aseXML SCHEMA CHANGE REQUEST

PREPARED BY:	PIUS KURIAN
DOCUMENT REF:	CR 41
VERSION:	1.1
DATE:	16 FEB 2011
DRAFT/FINAL	FINAL

Australian Energy Market Operator Ud ABN 94 072 010 327

Change Request 41 proposes to modify the ServiceOrderRequest aseXML transactions by increasing the CoC field length from seven to eight.

Figure 2-2 GasServiceOrderDetails

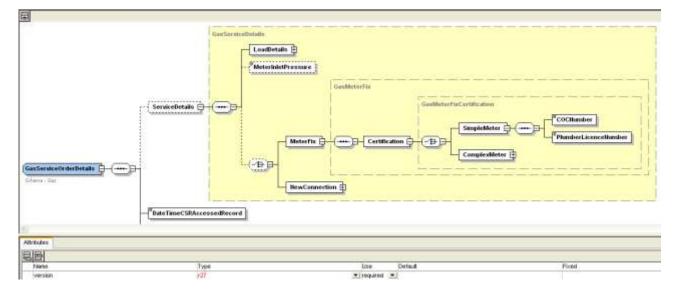
The version attribute of GasServiceOrderDetails has been revised to r27.
